Summary of Items Discussed in APSEC Discussion Forum (ADF) 3/2025 on 8 August 2025

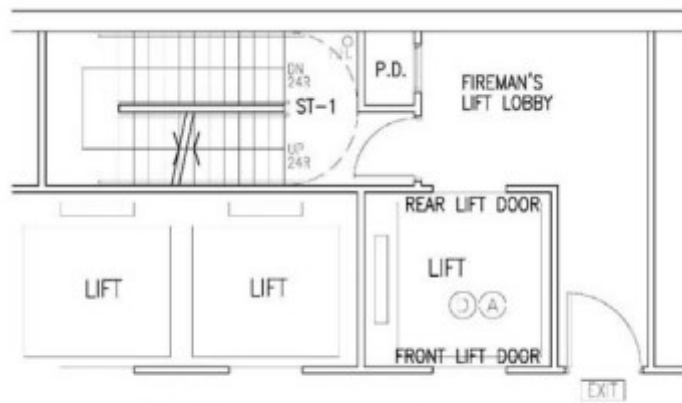
<p>Fig. 1</p>	
<p>11.</p>	<p><u>Fireman’s Lift and Fireman’s Lift Lobby</u></p> <p>Item 10 of ADF 4/2015 held on 28 August 2015 showed the below diagram regarding the arrangement of fireman’s lift and fireman’s lift lobby, in which a front/rear-opening elevator is used as a fireman’s lift with the front door lift facing the passenger lift lobby and the rear lift door facing the fireman lift lobby.</p>	<p>BD advised that according to Clause D11.1 of FS Code, every point of discharge from a fireman’s lift to the floor served should be through a lobby. Taking into account FSD’s advice, BD advised that the proposed arrangement was considered not acceptable.</p>

According to the summary of discussion of the item, the arrangement as shown in the above diagram would no longer be acceptable to the Fire Services Department (FSD) unless the lobbies which the firemen's lifts open to are firemen's lift lobbies complying with Clause D11.1 and D11.4 of FS Code.

Automatic Fire Shutter in front of the lift door

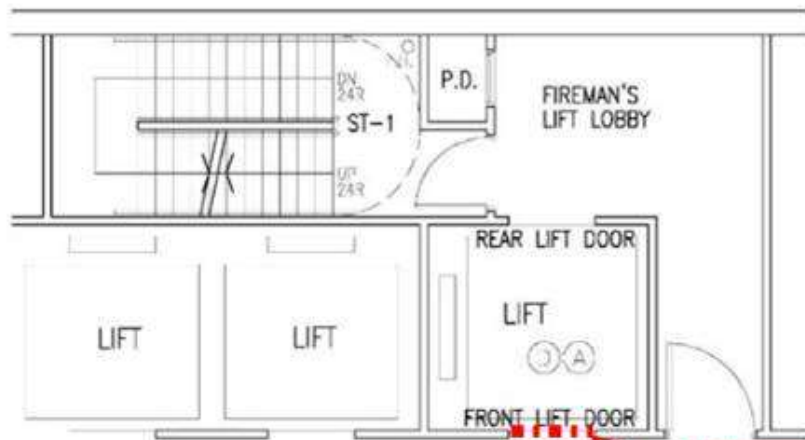
Please advise whether the arrangement shown in the below diagram, with the provision of an automatic fire shutter with an FRR of -/120/120 in front of the front lift door to separate the fireman's lift from the passenger lift lobby in case of fire, is considered acceptable to BD and FSD.

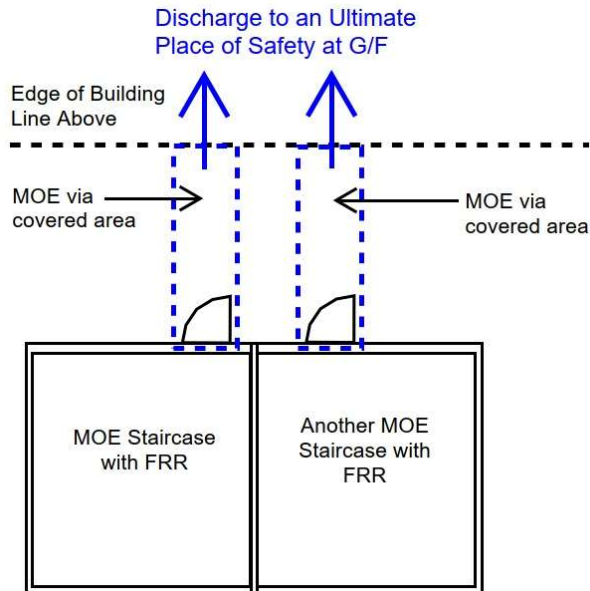
14.	<p><u>Covered Exit Route at Ground Storey</u></p> <p>According to Item 8 of ADF 1/2025 held on 14 February 2025, BD</p>	<p>BD advised that according to Clause B5.7 of FS Code, the walls enclosing</p>

confirmed that item 9 of ADF 2/2012 held on 16 March 2012 was still pertinent, that “the design of the ground storey discharge point which is recessed from the ultimate edge of the building may be acceptable if the covered recessed area is a common area, open in design, and not encumbered with features carrying fire hazards.”. On such basis, as illustrated in the below diagram, would BD please advise if the covered exit route leading from a required staircase to the ultimate place of safety at the ground storey can be located in proximity of the covered exit route leading from another required staircase, including that serving the basement.

the required staircase illustrated in the diagram should be returned along the frontage of final discharge for a distance of not less than 450 mm wide. The proposed design as illustrated in the diagram might be acceptable on case basis if the covered recessed area was a common area, open in design, not encumbered with features carrying fire hazards, and provided with a separating distance of not less than 450mm between the two notional exit routes.

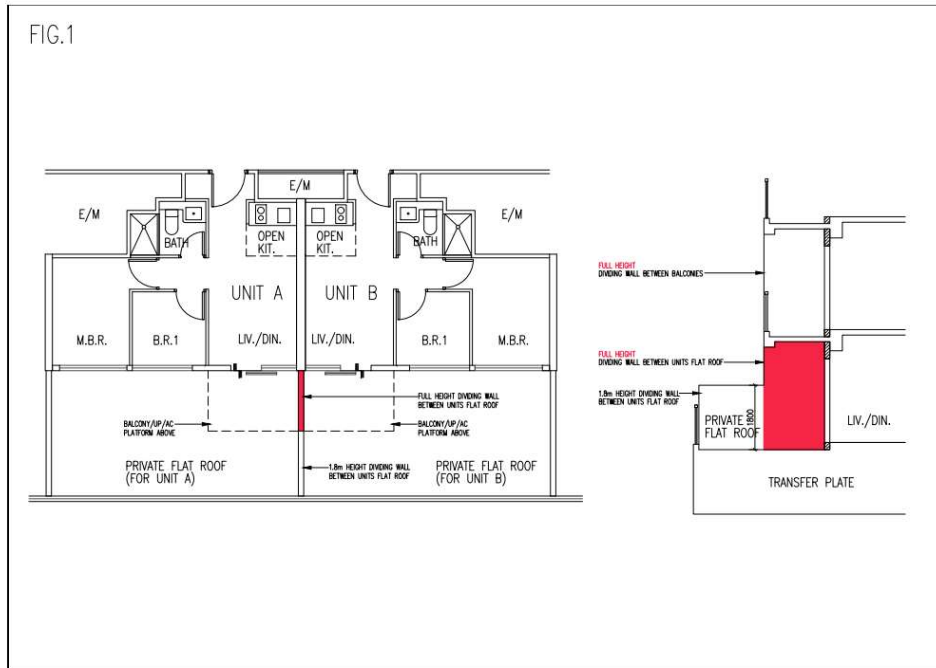
<p>16. <u>Private Flat Roof of Residential Units at the Lowest Storey</u></p> <p>For private residential development, it is quite common that the residential units located at the lowest storey (i.e. immediately above the transfer plate) are designed with access to the adjoining private flat roofs pertaining to the respective units. We understand that it is acceptable for the covered portion of such private flat roof which are underneath the balcony/UP (or combined balcony/UP/AC platform) of the unit above be separated from the private flat roof of the adjoining unit by a full height wall, similar to the separating wall between balconies/UPs (or combined balconies/UPs/AC platforms) of adjoining units (Figure 1 below refers). Please advise if our understanding</p>	<p>BD advised that HKIA's understandings illustrated in both figures were correct provided that the lowest balcony at Figure 2 was cantilevered and adequate access for maintenance to the soffit of the lowest balcony at Figure 2 was provided.</p>

is correct.

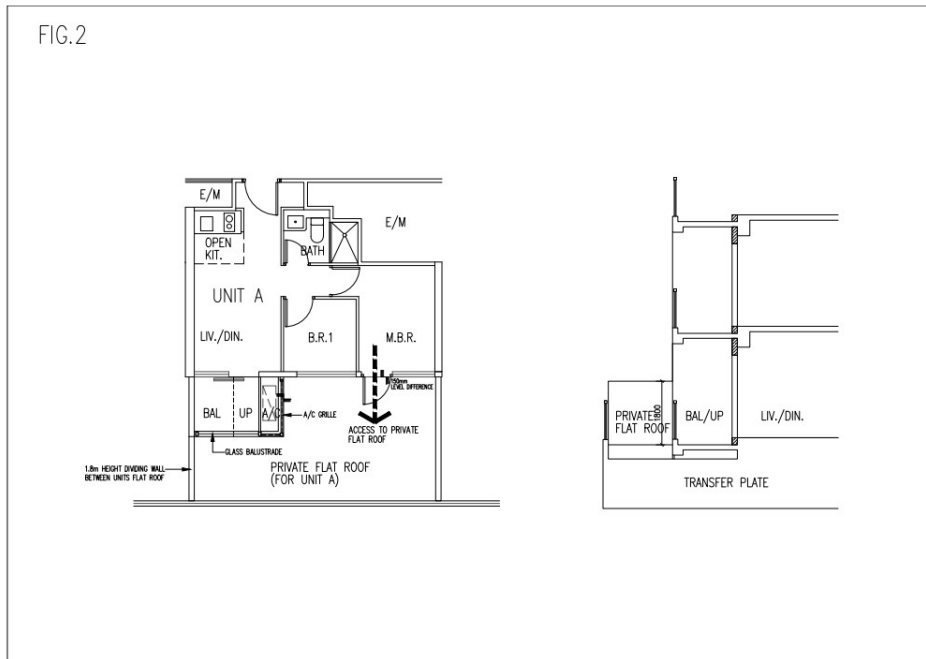
In case the residential unit located at the lowest storey is designed with balcony/UP (or combined balcony/UP/AC platform), it is also acceptable for the adjoining flat roof be designated as private flat roof pertaining to such unit, providing that such private flat roof could not be accessed through the balcony/UP (or combined balcony/UP/AC platform) (Figure 2 below refers). Please advise if our understanding is correct.

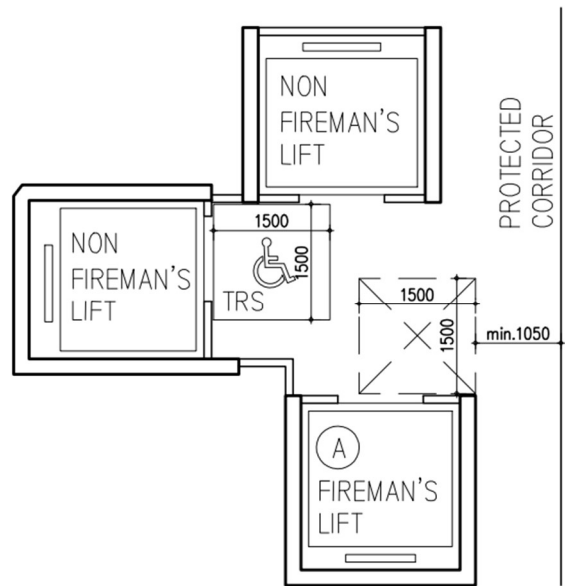
<p>Items raised by AAP</p>		
<p>22.</p>	<p><u>Temporary Refuge Space (TRS) at Lift lobby</u></p> <p>Clause B30.1 of the FS Code requires that “<i>at least one temporary refuge</i></p>	<p>BD advised according to Clause B16.1 of the FS Code, every lift lobby</p>

space with an area of not less than 1.5 m x 1.5 m should be provided within the protected exit or fireman's lift lobby" and such space should not reduce the minimum area of a fireman's life lobby. In some proposed developments as illustrated in the below diagram, the space of fireman's lift lobby is so limited that the TRS can only be placed in front of the doors of other lifts which are not designated as fireman's lifts. Could BD advise if such arrangement is acceptable?

should have access, without any obstruction and lockable door, to an exit route. Such access should be available at all times to any person who may come out from a lift car to the lift lobby. As such, the proposed arrangement of the TRS in the diagram causing an obstruction to the access of the lift lobby was not acceptable.

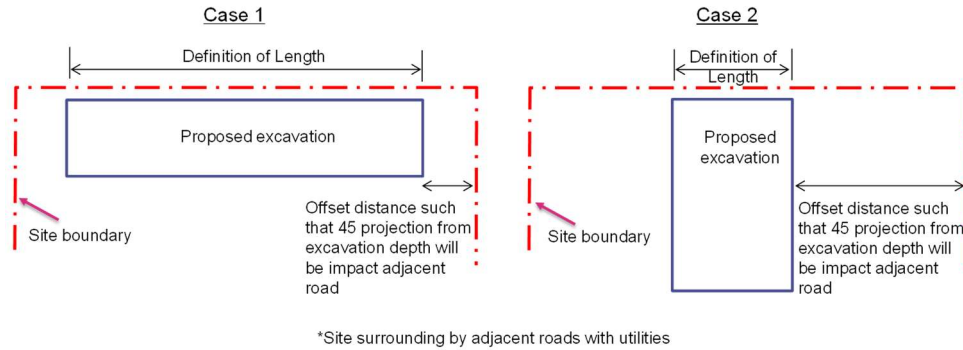
<p>25. <u>Criteria for Submission of Excavation and Lateral Support (ELS) Plans</u></p> <p>Paragraph 3 of PNAP APP-57 is extracted as follows:</p> <p>3. ELS plans will be required to be submitted to the Buildings Department (BD) for approval where the excavation works to be carried out are:</p> <ul style="list-style-type: none"> (a) deeper than 2.5 m and greater than 5 m in length; and (b) liable to affect any road, building, structure, slope steeper than 30° or water main 75 mm in diameter or greater, the affected area being defined as within the 45° line up from the base of the excavation to the ground surface. <p>According to item 18 of ADF 4/2022 held on 12 August 2022, our understanding is that ELS plans are only required when both conditions</p>	<p>BD advised that ELS plans were required to be submitted for approval when both criteria in paragraph 3(a) and (b) of PNAP APP-57 were met. The length of the excavation in paragraph 3(a) should refer to the single maximum dimension of the entire excavation area on the plan, irrespective of the construction sequence and/or proximity to the site boundary. As a result, ELS plans were required to be submitted to BD for approval for the excavation works illustrated in the diagrams.</p> <p>On account of a member’s opinion that the greatest dimension of the excavation in Case 2 illustration diagram was further apart from the site such that the requirement for ELS submission might be relaxed, BD would</p>

under paragraphs 3(a) and 3(b) of the said PNAP are met. We have a follow up query on the definition of length as stated in sub-clause (a), whether it refers to the length of excavation parallel to site boundary, irrespective to maximum or least dimension on plan of a rectangular-shaped excavation, as illustrated in the below diagrams:

An excavation of a long narrow trench to house utilities, say 20 m by 3 m wide by 3 m deep, is to be carried out near the site boundary abutting a public road. Based on the construction sequence, the trench will be opened in sections in order to maintain site traffic, such that in each section a maximum length of 5 m will be excavated and then backfilled before the next section is commenced. If the answer to the above query is affirmative, our understanding is that such excavations works would not require the submission of ELS plans to BD for approval. Would BD please confirm if our outstanding is correct?

[**Post meeting note:** In response to member’s opinions, BD conducted a further review of the criteria in paragraph 3(a) and (b) of PNAP APP-57, BD considered that the length of the excavation in paragraph 3(a) should refer to every single dimension of the entire excavation area with a length greater than 5m, irrespective of the construction sequence and/or proximity to the site boundary.]
